ADDRESS : 288 TILDEN HOWINGTON DR SUBDIV: MAMIE BELL PH# 1&2&5 46LOTS
 CONTRACTOR : MCCLOSKEY BUILDERS INC PHONE : (910) 813-3428
 OWNER : DAKOTA LAND PARTNERS LLC PHONE :
 PARCEL : 13-0630-01- -0029- -22-
 APPL NUMBER: 17-50040625 CP NEW RESIDENTIAL (SFD)
 DIRECTIONS : T/S: 01/26/2017 09:25 AM LBENNETT --
 288 TILDEN HOWINGTON DRIVE - MAMIE BELL
 T/S: 03/29/2017 09:11 AM DJOHNSON --
 ****PREMISE NO 55584900*****

STRUCTURE: 000 000 36X34 4BDR W/GARAGE STEMWALL SLAB

RE: 967233 - Lot 82A Mamie Bell, Harnett Co., NC

Project Customer: McCloskey Bldrs Project Name: 967233

| Job 967233 | Truss F102 | Truss Type Floor | Qty 3 | Ply 1 | Lot 82A Mamie Bell, Harnett Co., NC Job Reference (optional) | 129829904 |

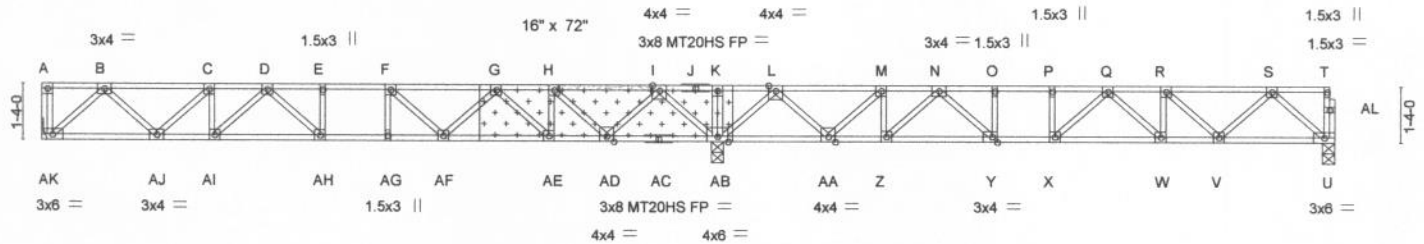
REPAIR:
TRUSS MEMBER H-I IS MISSING.
PLATES AT JOINTS H & I ARE DAMAGED.

INSTALL 2 X 4 SPF/DF/SP NO.2
CUT TO FIT TIGHT.

ATTACH 3/4" PLYWOOD OR OSB GUSSET (23/32" RATED SHEATHING 48/24 EXP 1)
TO EACH SIDE OF TRUSS WITH CONSTRUCTION QUALITY ADHESIVE AND ONE ROW OF
(0.131" X 2.5") NAILS SPACED 2" O.C. FROM EACH FACE INTO EACH COVERED TRUSS MEMBER.

| Job 967233 | Truss F109 | Truss Type Floor Girder | Qty 1 | Ply 1 | Lot 82A Mamie Bell, Harnett Co., NC I29829905 |

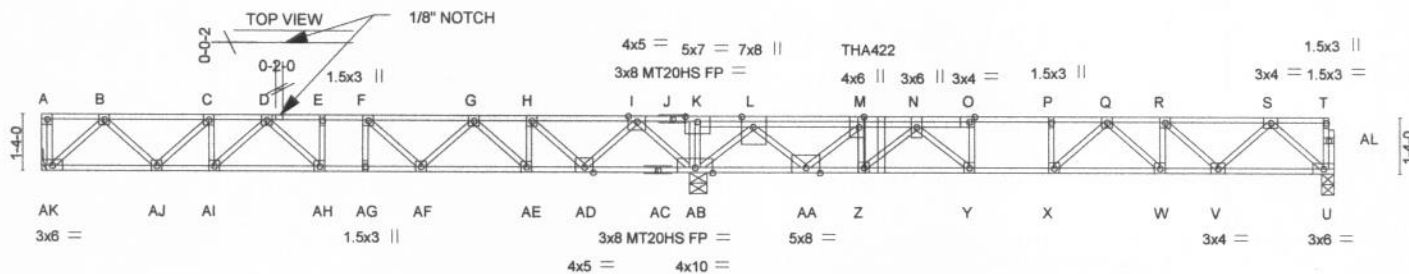
REPAIR: 2" x 1/8" NOTCH WAS CUT OUT OF THE TRUSS 1" TO THE RIGHT OF JOINT D.

NO REPAIR REQUIRED.
